APPENDIX E

Explanation of Bias in the Column Force Data, a Method for Correcting the Bias, and Re-Plotted Data From Both Phases I and II that is Corrected for the Bias

18 July 2000
B-H200-17005-ASI

Subject: Dual Elevator PCA Jam Ground Test - Egyptair 767-300ER SU-GAP, Accident Off Nantucket, Massachusetts – 31 October, 1999

CALC	B. Cook	17Jul00	REVISED	DATE	Captain's Column Force Bias During Test Condition 006 of Test 10-05	767-400ER VQ001
CHECK						Figure 3
APPD.						
APPD.					BOEING	PAGE 10 of 15

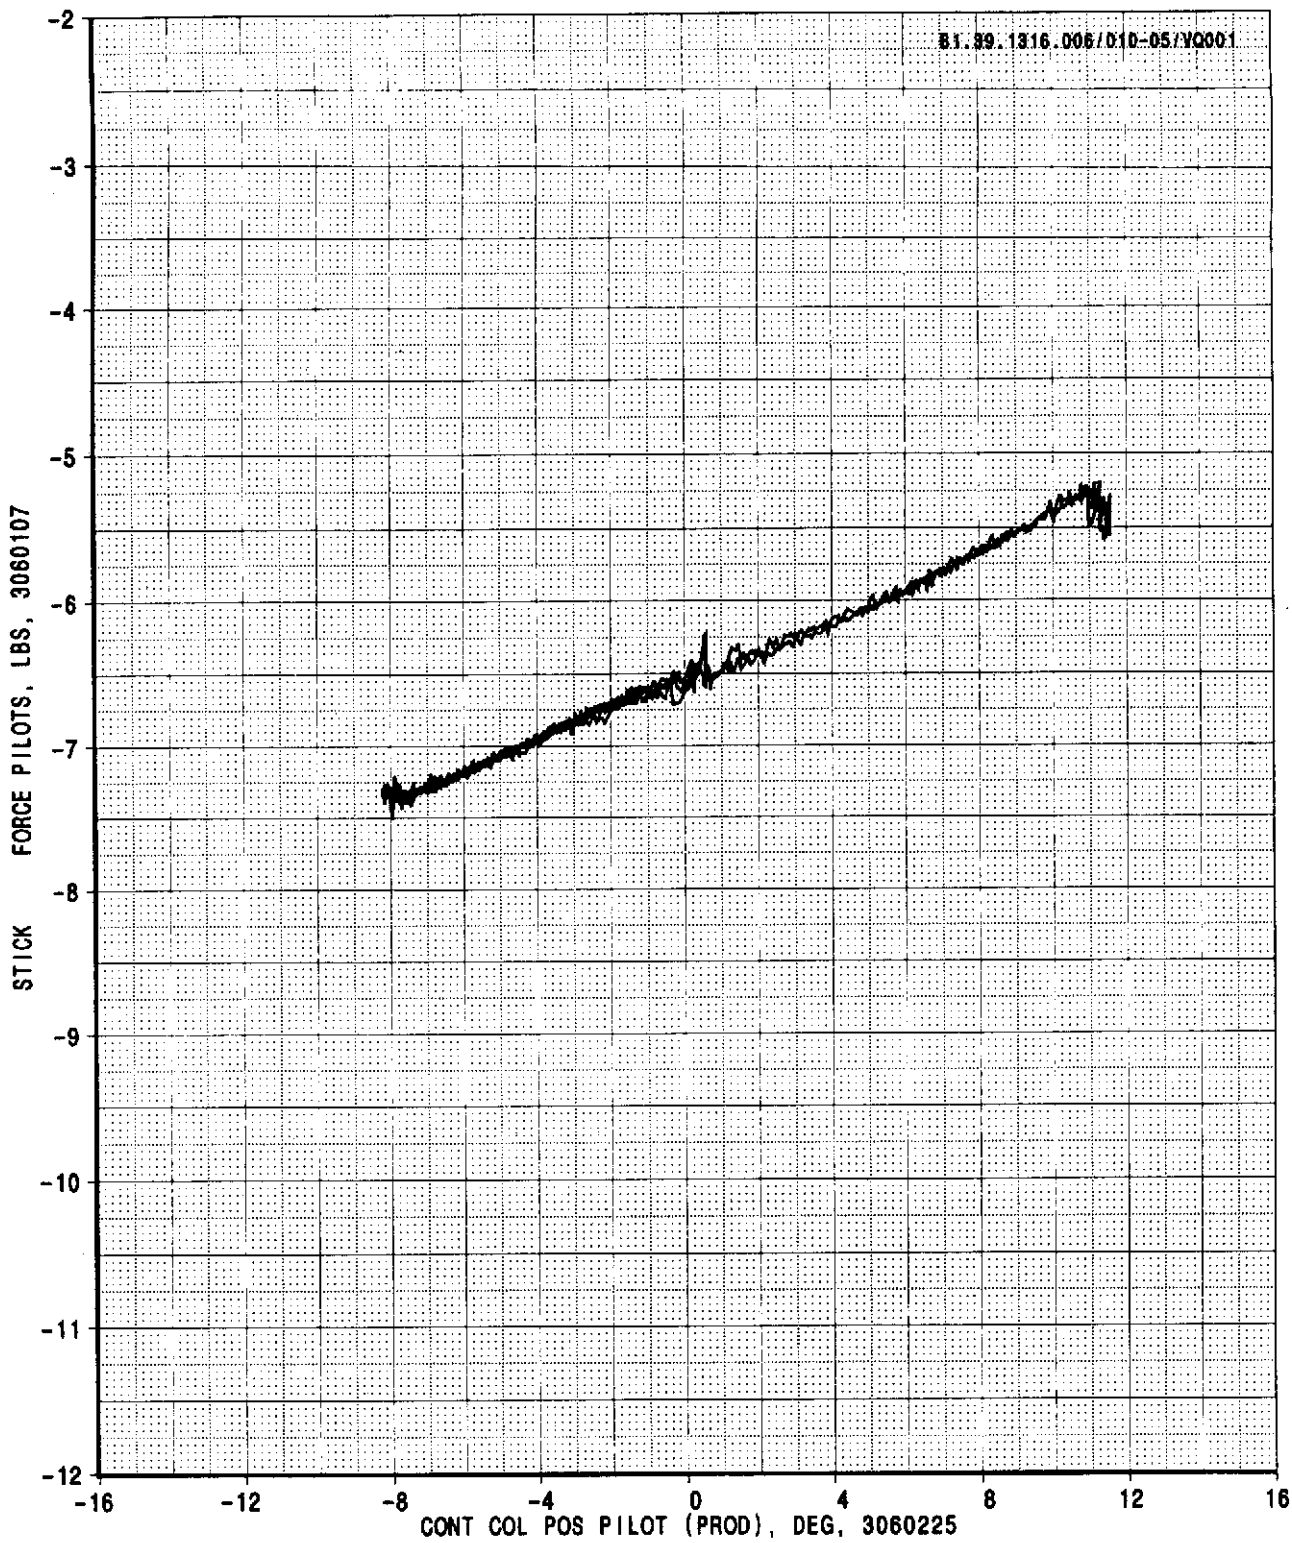
Figure 3 shows a plot of the captain's column force versus the captain's column position for a typical test condition in which the first officer alone made the column inputs. Since no pilot force was being applied to the captain's column during this condition, this plot shows the captain's column force bias directly.

Figure 3 has three characteristics that warrant explanation. The captain's column force bias is seen to be a positively sloped curve with very little hysteresis that is never equal to zero.

The positive slope characteristic on the column force bias of figure 3 is caused by the effect of gravity on the column mass located above the strain gage. Since our column force instrumentation derives "applied column force" based on a measurement of the total strain at the base of the control column, it is unable to distinguish between the applied pilot forces and the column mass unbalance forces. Since the magnitude of the column mass unbalance forces are roughly only +/- 1 pound of column force relative to those at zero degrees of column, they can be ignored without introducing any significant error. If greater accuracy is desired, the column mass unbalance forces could be accounted for in any computations because they are simply a function of the column angle.

There is very little hysteresis on the column force bias of figure 3. This minimal hysteresis is to be expected for slow column sweeps since there are no friction elements between the strain gage and the top of the control column. The fact that there is no hysteresis shows that the instrumented column force readings are repeatable during a test condition. Some hysteresis could occur on the column force bias trace as a result of either something bumping into the column or due to sudden changes in column velocity. Sudden changes in column velocity produce an inertial force that is sensed by the strain gage at the base of the column. Since most of our testing involved slow column

The column force bias shown in figure 3 is never equal to zero. This is a direct result of not removing the instrumentation bias during the calibration procedure. Since a normal calibration procedure would adjust the column force instrumentation output to read zero at the zero degree column angle, the column force instrumentation bias in this figure is about –6.5 pounds of column force. The magnitude of column force instrumentation bias is significant and needs to be subtracted from the total indicated column force in order to obtain the pilot applied force.

CALC	B. Cook	17Jul00	REVISED	DATE	Captain's Column Force Biases During Test 10-05	767-400ER VQ001
CHECK						Figure 4
APPD.						
APPD.					BOEING	PAGE 10 of 16

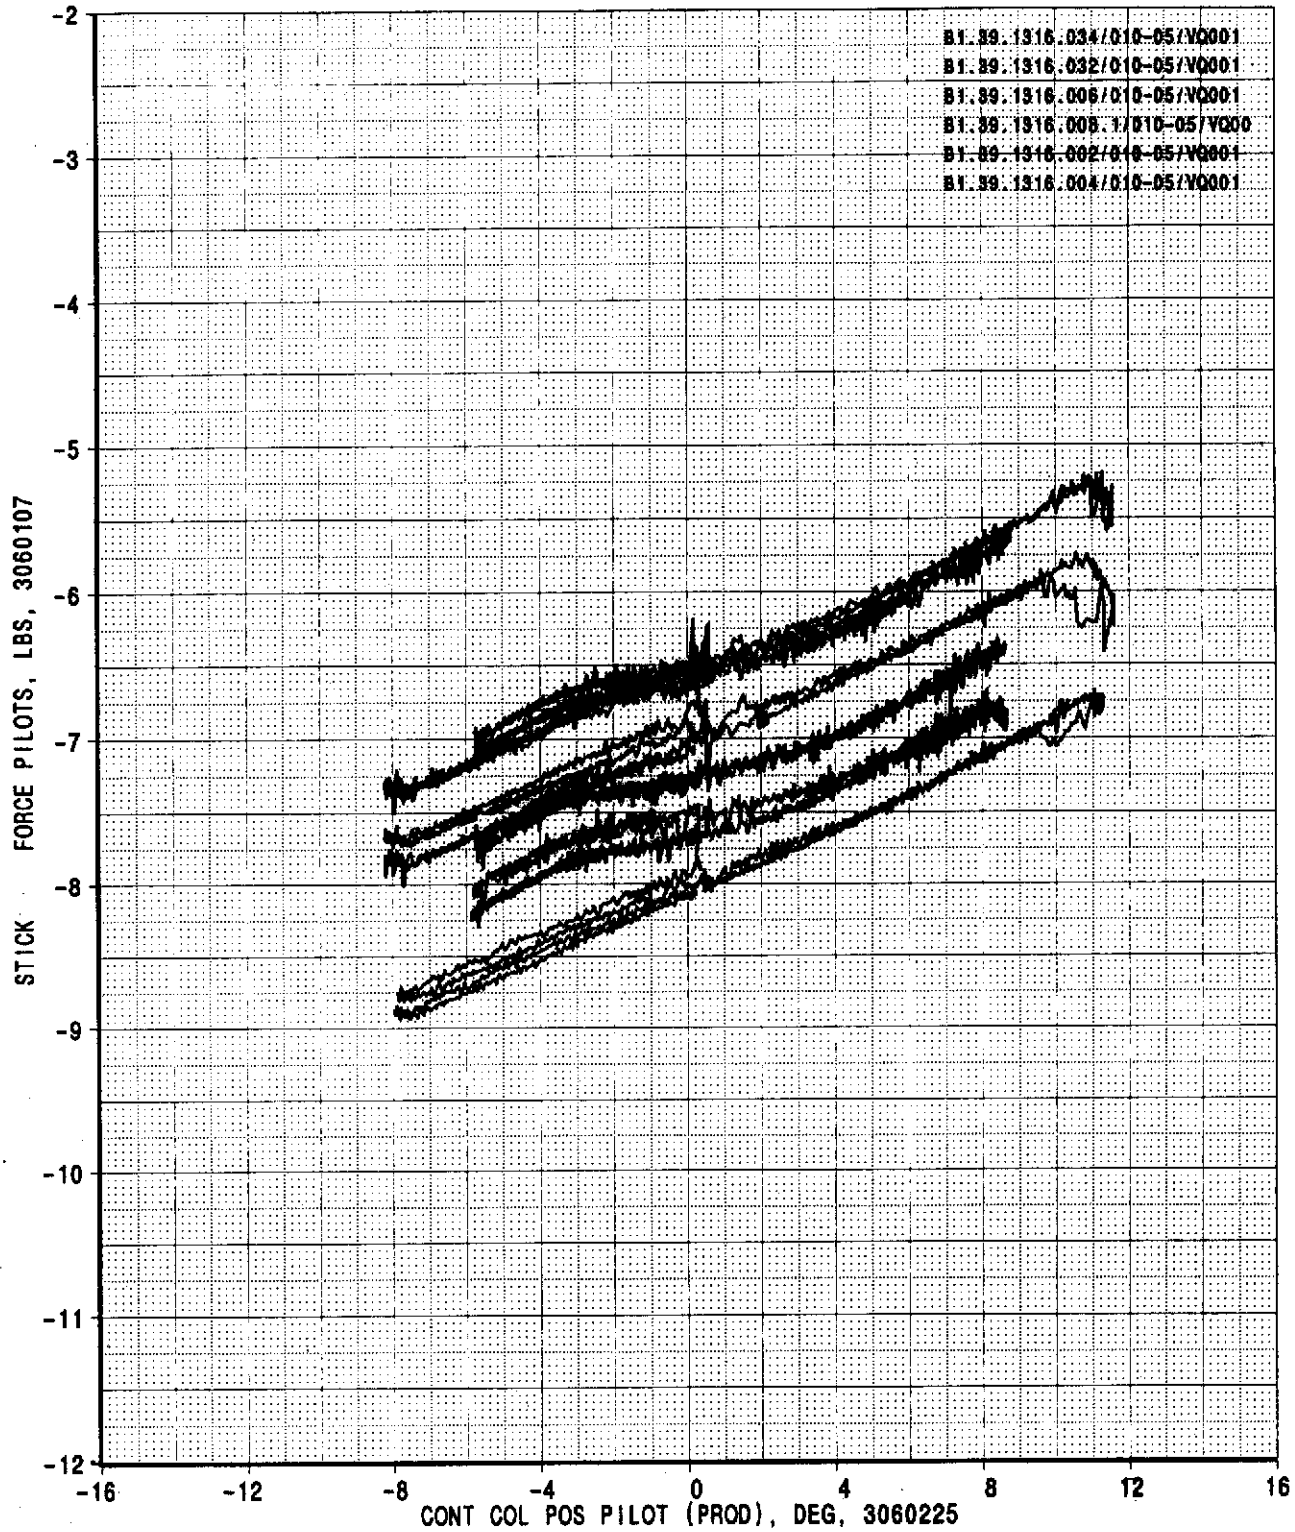
The captain's column force biases during test 010-05 are shown in figure 4. Figure 4 was created by plotting the captain's column force versus the captain's column position for all test conditions in which the first officer alone made the column inputs. Figure 4 is the same as figure 3 except that the column force biases were measured at different times throughout the day. Figure 4 shows a bunch of parallel lines. The fact that the lines in figure 4 don't lay right on top of each other shows that the column force instrumentation bias at zero degrees of column shifted during the course of the day within the range of –6.5 to –8.0 pounds of column force. The fact that these lines are parallel to each other demonstrates that even though the bias shifted throughout the course of the testing as a result of temperature changes, the gain of the instrumented column force was unaffected. Since the same mass unbalance force caused the characteristic slope of these lines, any change to the gain of the instrumented column force would have resulted in non-parallel lines.

Examination of figures 4, 5, 6, and 7 reveals that the column force instrumentation biases all shifted during the course of the day's testing. The cause of this shifting is changes in temperature during the course of the testing. During the design of the strain gage simulator circuits, no attempt was made to produce biases that were constant with respect to temperature. For figures 4, 5, and 6, the shift in the column force instrumentation bias is less

CALC	B. Cook	17Jul00	REVISED	DATE	First Officer's Column Force Biases During Test 10-05	767-400ER VQ001
CHECK						Figure 5
APPD.						
APPD.					BOEING	PAGE 13 of 16

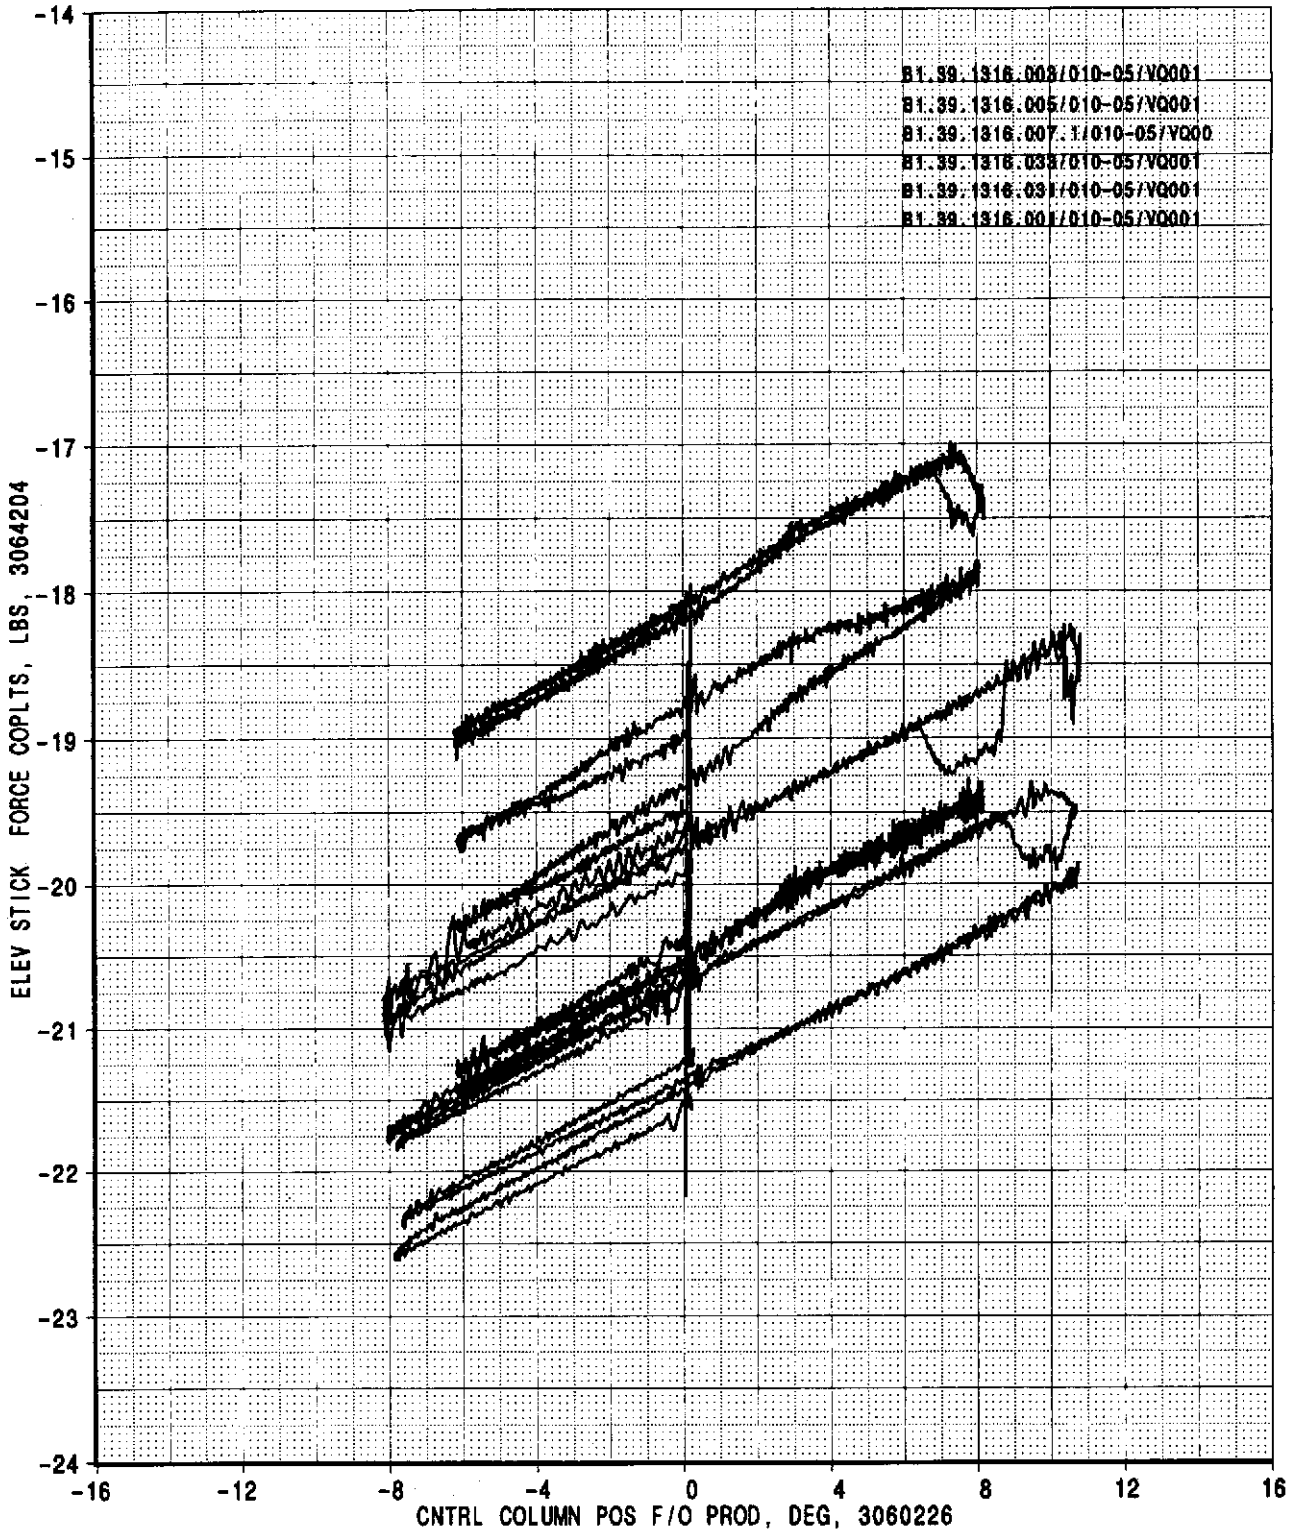
The First Officer's column force biases during test 010-05 are shown in figure 5. Figure 5 was created by plotting the first officer's column force versus first officer's column position for all test conditions where the captain alone made the column inputs.

CALC	B. Cook	17Jul00	REVISED	DATE	Captain's Column Force Biases During Test 10-18	767-400ER VQ001
CHECK						Figure 6
APPD.						
APPD.					BOEING	PAGE 13 of 16

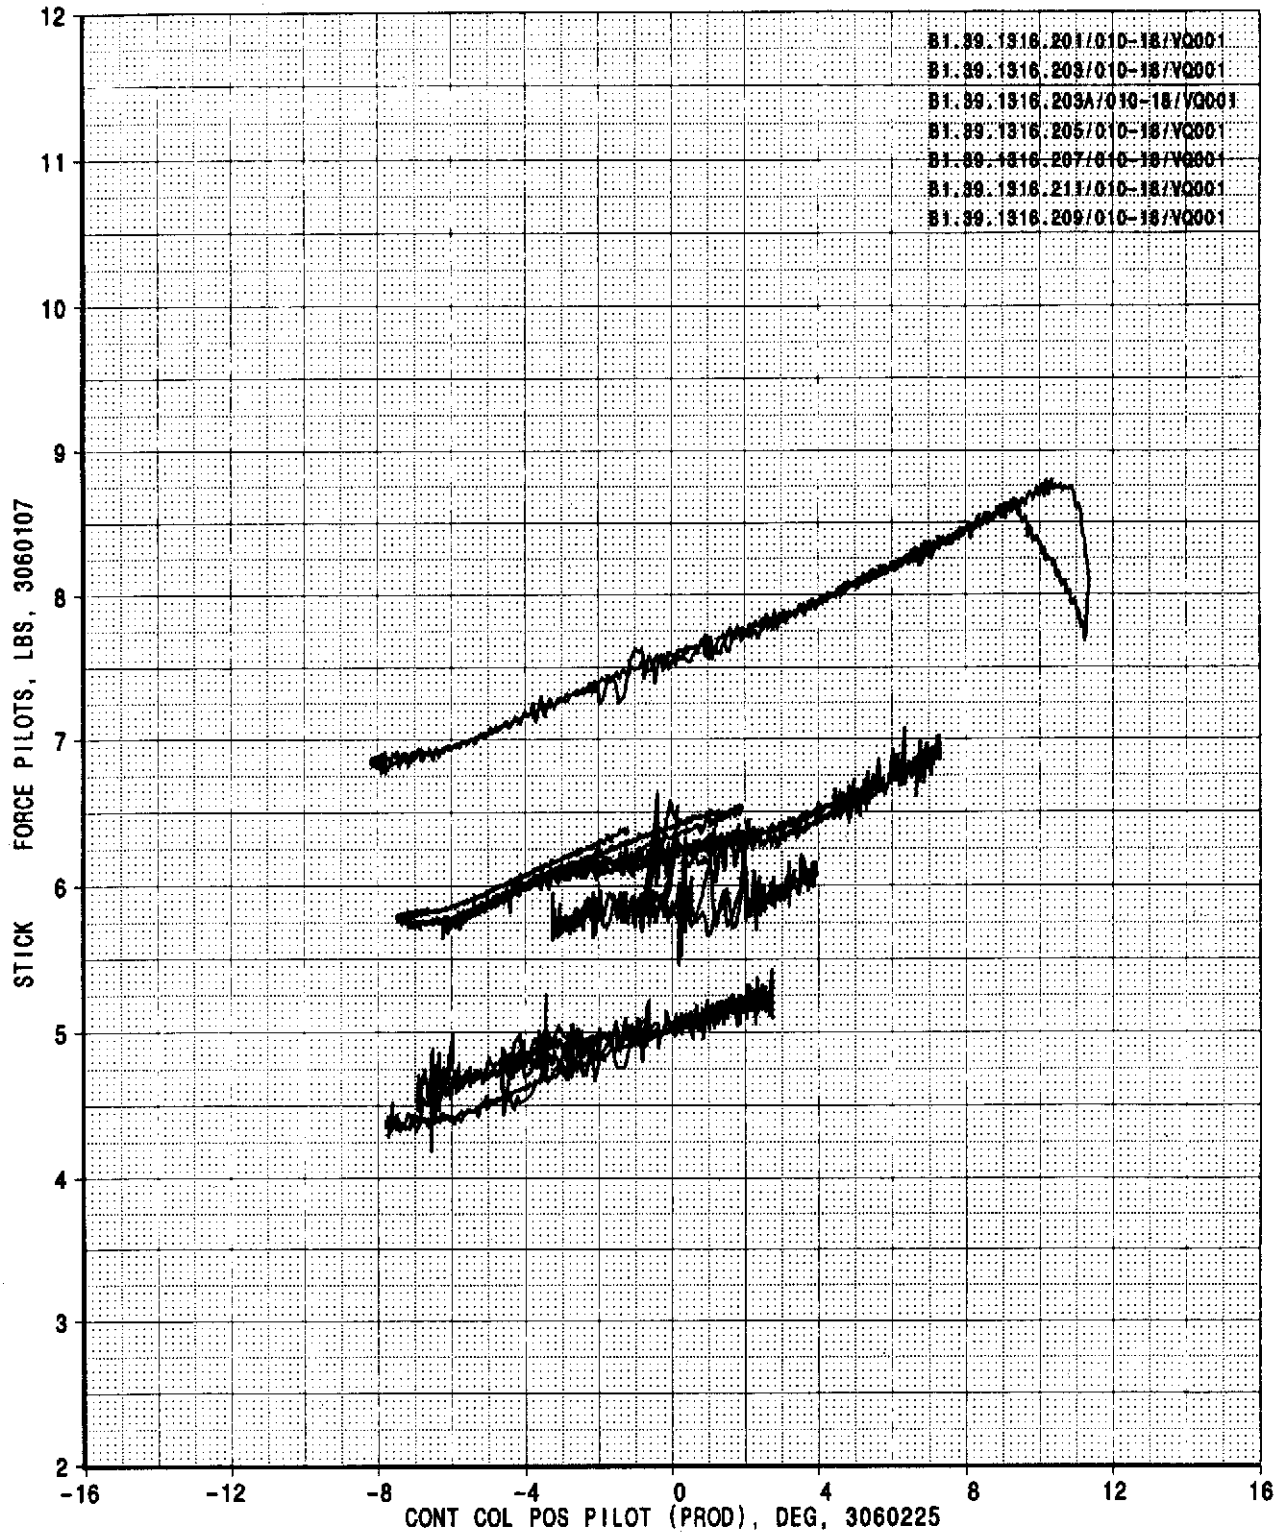
The captain's column force biases during test 010-18 are shown in figure 6. The First Officer's column force biases during test 010-18 are shown in figure 7. These plots were generated using the same methods described above for figures 4 and 5.
